From: Kate Tudehope <KTudehope@ethosurban.com>
Sent: Friday, 14 September 2018 8:54 AM
To: Jorge Van Den Brande
Cc: Byron Williams
Subject: Loreto Kirribilli - Conditions and bike plan
Attachments: Loreto Kirribilli SSD_Schedule of Conditions_Final Response to IPC_14Sept2018.pdf; DA-2302 Northern Precinct - Lower Ground 3.pdf

Following Tuesday's briefing, please see attached our proposed changes to the conditions as well as an updated Plan showing the revised bike parking location.

Staged Redevelopment of Loreto School (Concept and Stage 1)
Draft Conditions for SSD 16_7919
14th September 2018

title
Northern Precinct Plans
Northern Precinct - Lower Ground 3

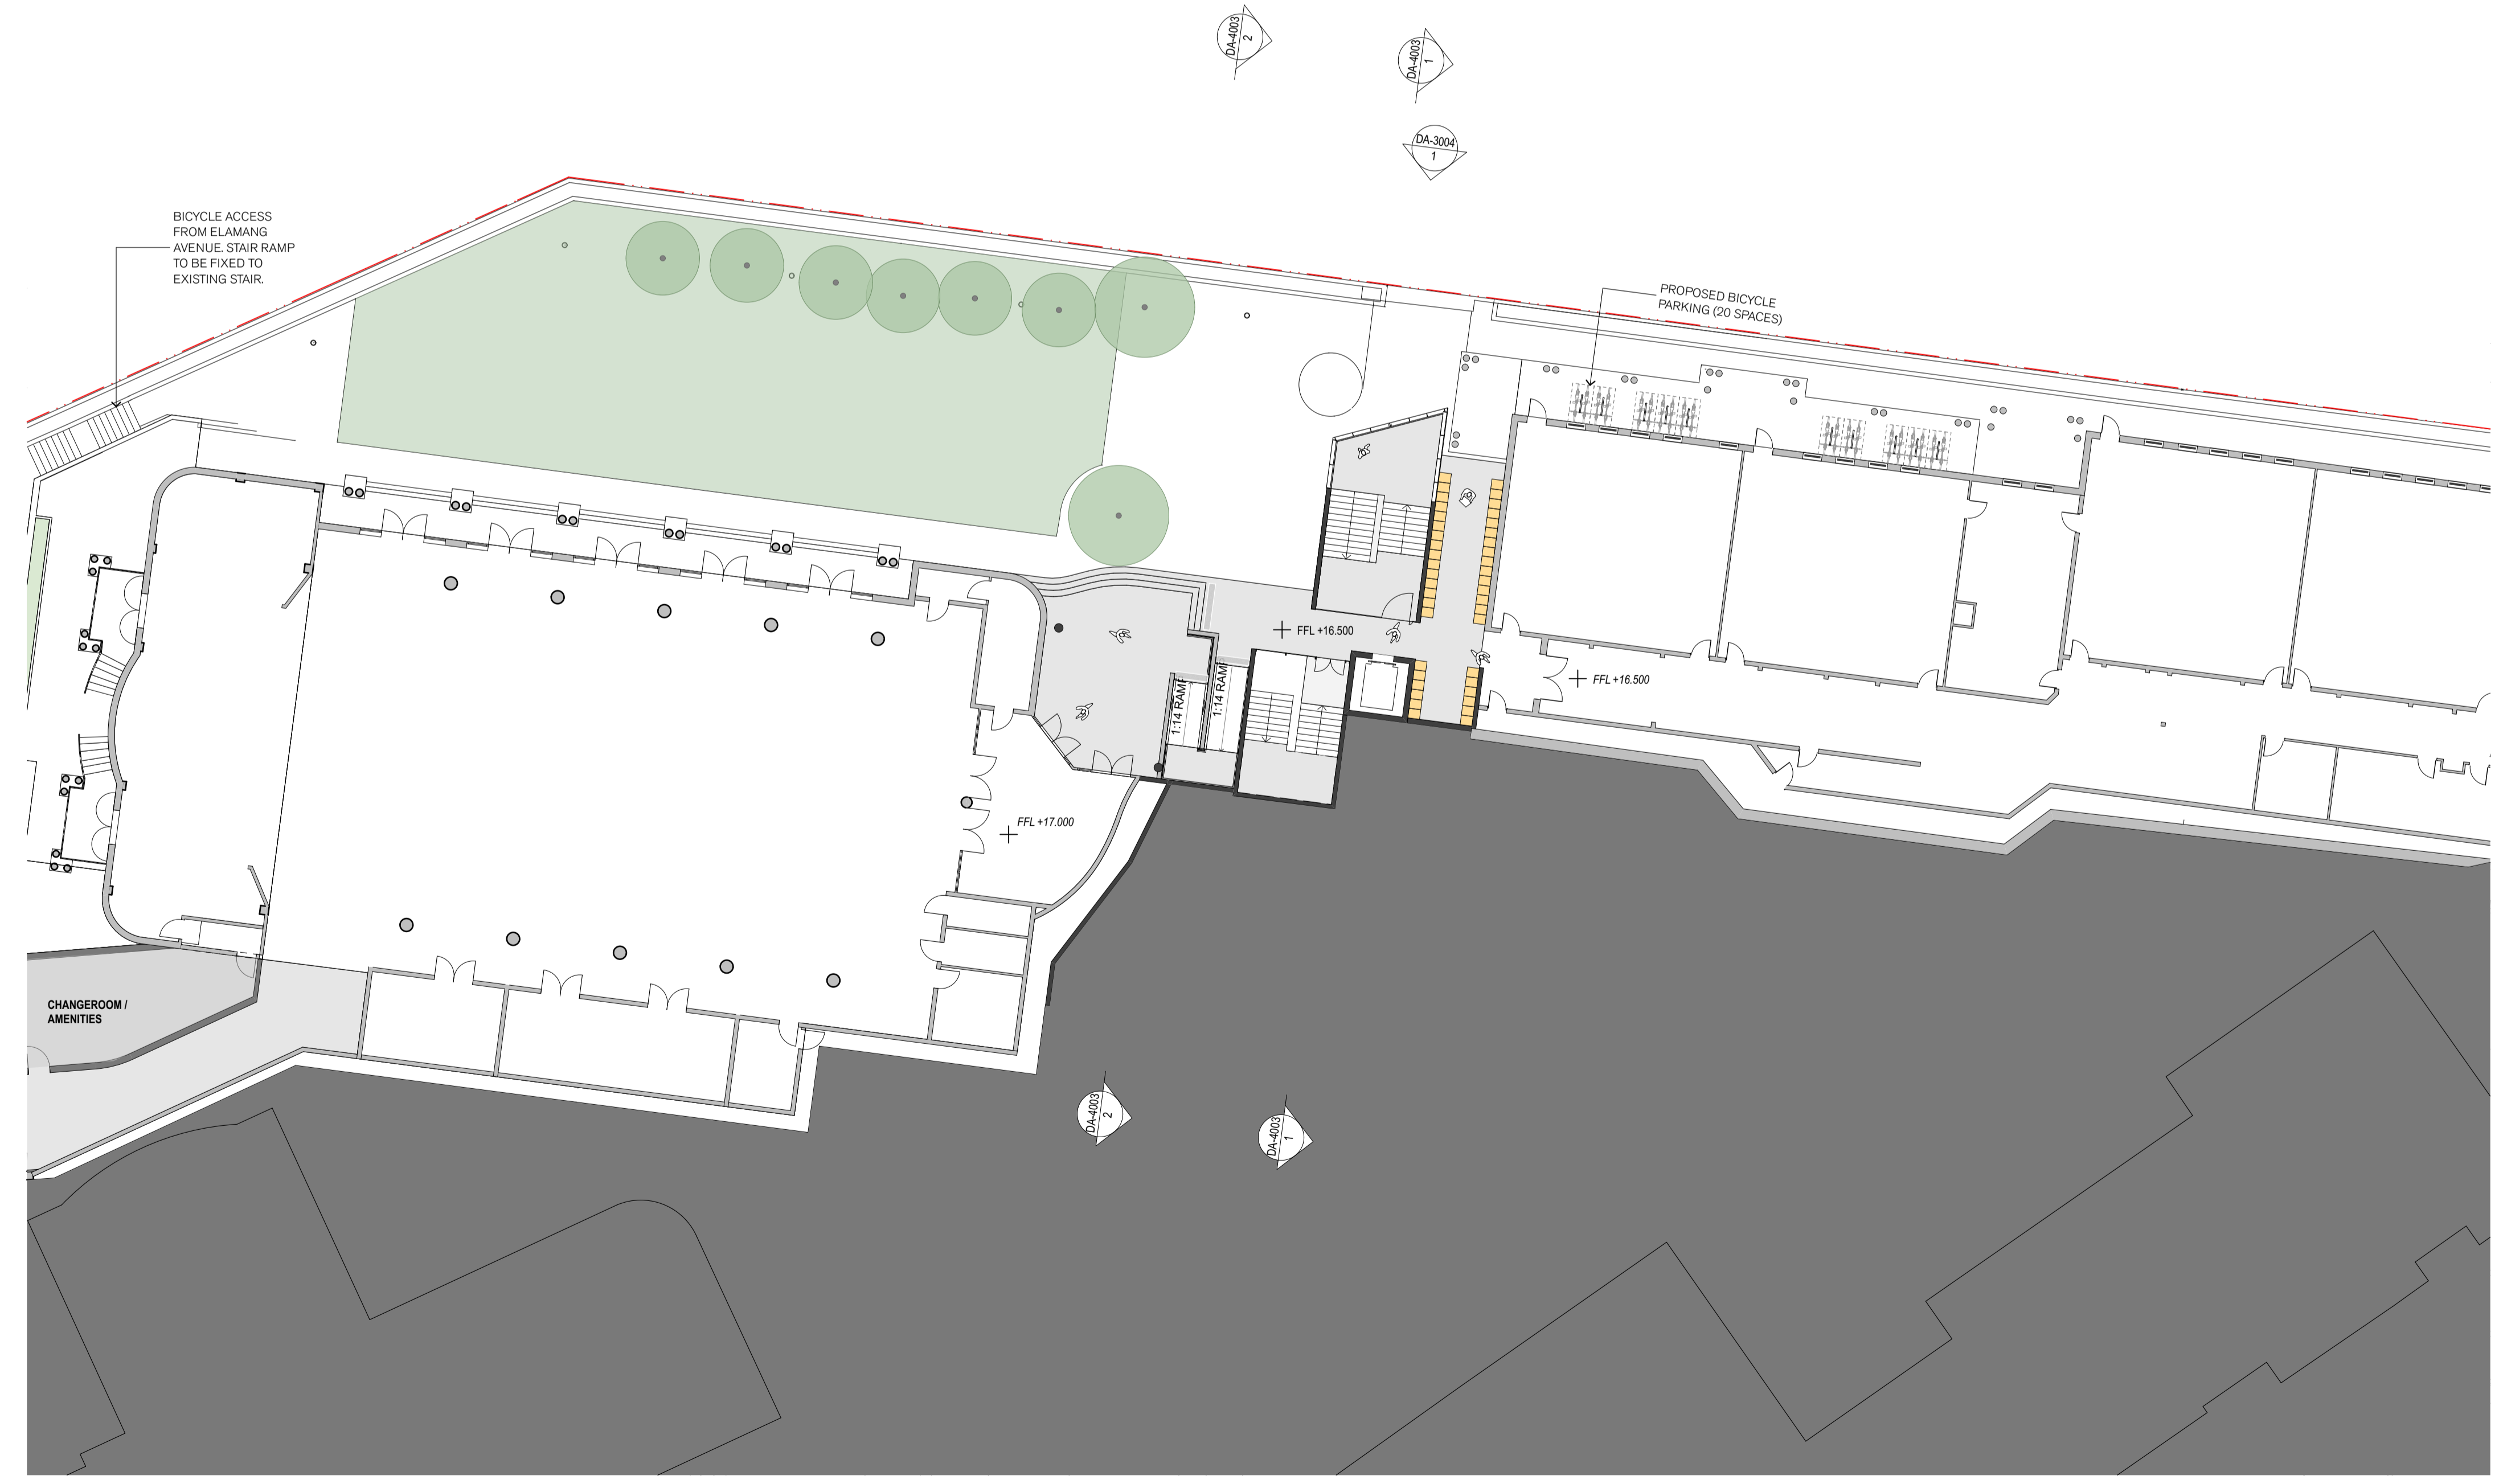
B12	<p>Plans demonstrating compliance with the following requirements for secure bicycle parking and end-of-trip facilities must be submitted to the satisfaction of the Principal Certifying Authority:</p> <p>(a) the provision of a minimum 20 student bicycle parking spaces with end-of-trip facilities in the Centenary Hall storage area adjacent to the Science Building, with end-of-trip facilities to be provided in the new Learning Hub;</p> <p>(b) the layout, design and security of bicycle facilities must comply with the minimum requirements of AS 2890.3:2015 Parking facilities - Bicycle parking, and be located in easy to access, well-lit areas that incorporate passive surveillance;</p> <p>(c) the details of the bicycle spaces and the ramp providing access to the bicycle parking area from Elamang Avenue;</p> <p>(d) the provision of end-of-trip facilities for staff in accordance with the ESD Design & As Built rating tool;</p> <p>(e) appropriate pedestrian and cyclist advisory signs are to be provided; and all works/regulatory signposting associated with the proposed developments must be at no cost to the relevant roads authority.</p>	<ul style="list-style-type: none"> The bicycle parking spaces were originally proposed to be located in Centenary Hall. However, this space is used for HSC exams, and so it is ‘out of bounds’ for parts of the year. The School has determined that it would be more appropriate to locate the spaces on the Elamang Avenue façade of the existing Science Building, beneath the verandah. 20 bicycle spaces can be accommodated in this location. A revised Northern Precinct Plan Stage 1 has been provided to show the revised location of the bicycle parking spaces. It is requested that this plan be listed in the conditions of consent.
